## **RESPONSE TO NOTICE OF LRD OPINION**

### **BALLINACURRA MILL LRD (Ref. PPE22 605)**

**128 Residential Units, 5 Commercial Units, café, creche & associated site works  
at Rose Hill House & Ballinacurra Mill, Ballynacorra East, Midleton, Co.Cork**

**6.2.2026**

Proposed ground floor of Cereal Store

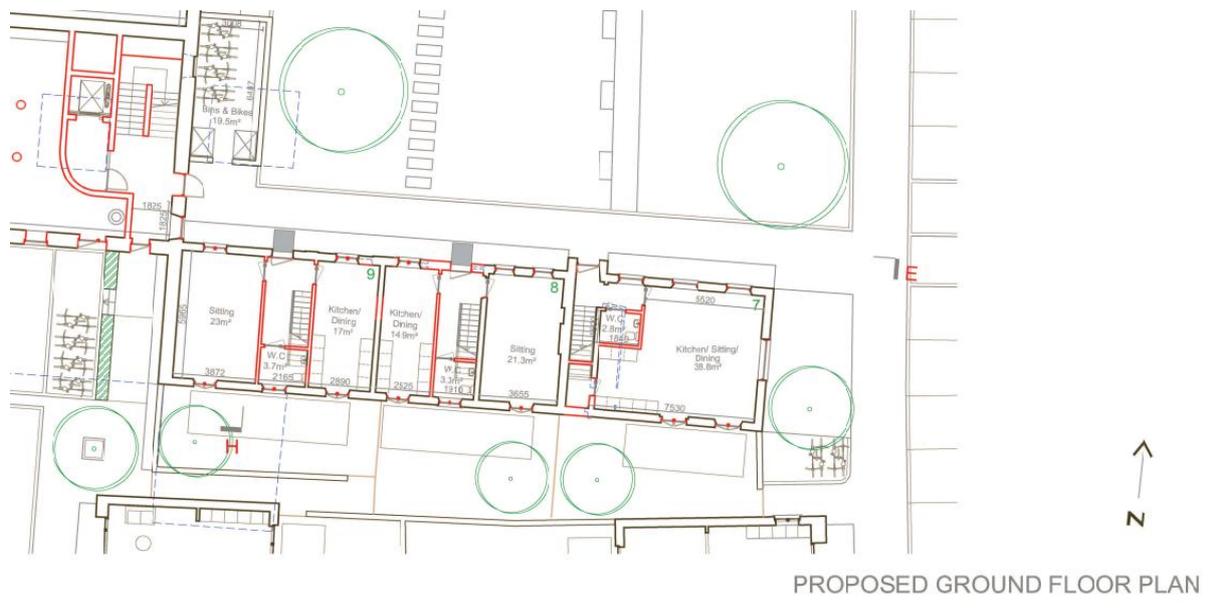
*The demolition of the 'cereal lab' is unacceptable.*

The Cereal Lab is retained and will be converted into 3 no. dwellings.

Taking in charge diagram.

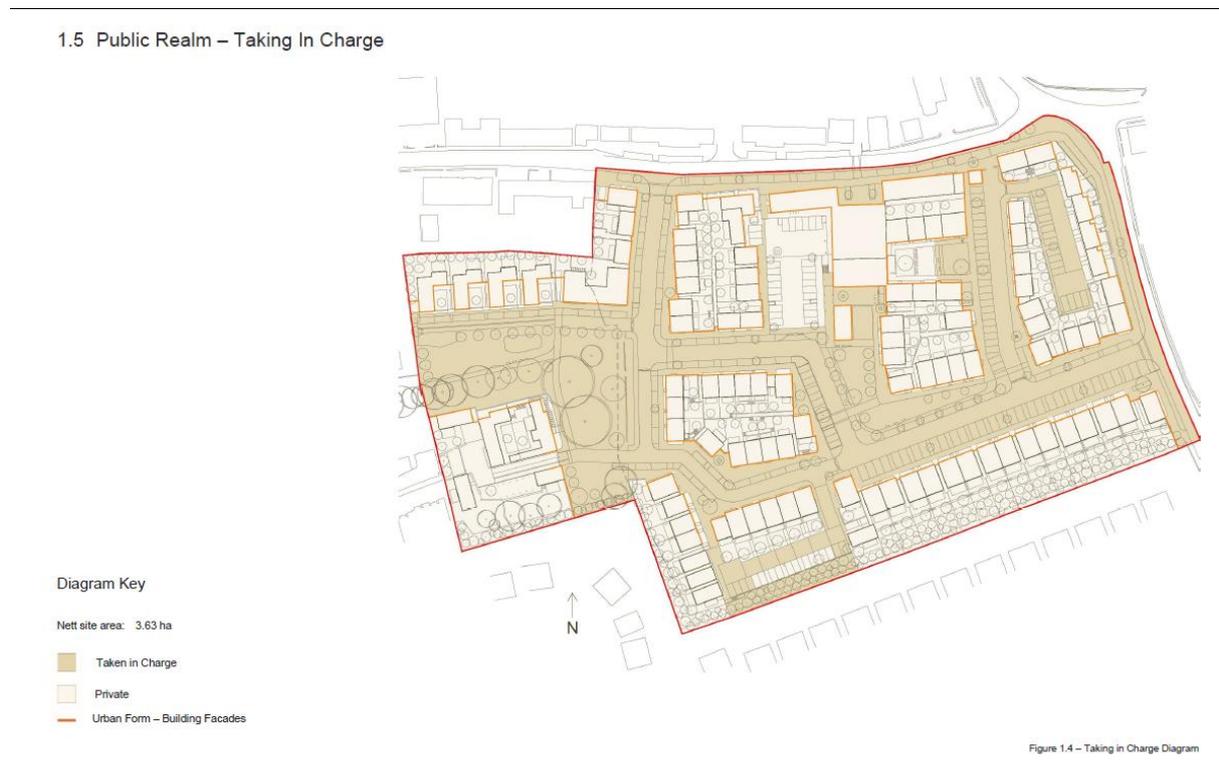
*The submitted Taking-in-Charge plan is unacceptable and should be revised to exclude mixed-use/ apartment blocks and commercial units and associated services such as amenity spaces, car and bicycle parking, bin storage.*

Refer to the revised Taking in Charge diagram prepared by Fourem Architects in the Architectural Design Statement. It now excludes mixed-use/ apartment blocks and

commercial units and associated services such as amenity spaces, car and bicycle parking, bin storage.
